Access Compliance Report

Public Rights-of-Way

Intersection ID: 22684	Main Street: OUTER_BRIDGE_LN	Cross Street: OXWYNN_LN	Location: NE
ADA ID: 7F2123C2FADE	Ramp Type: PerpDiag	Initial Pass/Fail: Fail	Overall Compliance: No
Severity Score: 50			
Codes/Mitigation Info/Possible Solution		Field Measurements/Component Compliance

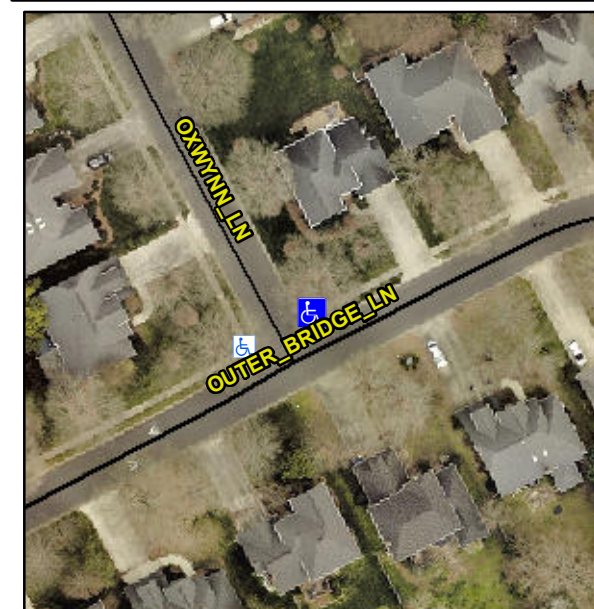
R304.2.2, R304.5.3

Compliance	Description	Data	Compliance	Description	Data
N/A	Ramp Length (in)	49.0	No	Ramp Slope (%)	12.6
Yes	Ramp Width (in)	48.0	No	Ramp XSlope (%)	7.1
N/A	Flare Type LT	N/A	N/A	Flare Type RT	N/A
N/A	Flare Slope LT (%)	N/A	N/A	Flare Slope RT (%)	N/A
N/A	Flare Traversable LT?	N/A	N/A	Flare Traversable RT?	N/A
N/A	Landing Length (in)	N/A	N/A	DWS Provided?	N/A
N/A	Landing Width (in)	N/A	N/A	DWS Contrast?	N/A
N/A	Landing Slope (%)	N/A	N/A	DWS Length (in)	N/A
N/A	Landing X Slope (%)	N/A	N/A	DWS Full Width?	N/A
N/A	Landing Curb? (Y/N)	N/A	N/A	DWS Offset (in)	N/A
N/A	Shared Landing?	N/A			
N/A	Gutter Ponding?	N/A	N/A	Gutter Slope (%)	N/A
N/A	Gutter Lip Ht (in)	N/A	N/A	Gutter X Slope (%)	N/A
N/A	Painted X Walk1?	No	N/A	Painted X Walk2?	No
	X Walk 1 Direction	To W		X Walk 2 Direction	To S
N/A	X Walk 1 Width (in)	N/A	N/A	X Walk 2 Width (in)	N/A
	X Walk 1 Slope (%)	1.2		X Walk 2 Slope (%)	3.6
	X Walk 1 X Slope (%)	5.1		X Walk 2 X Slope (%)	2.4

Remove & Replace Curb Ramp With Two New Directional Ramps or Equivalent.
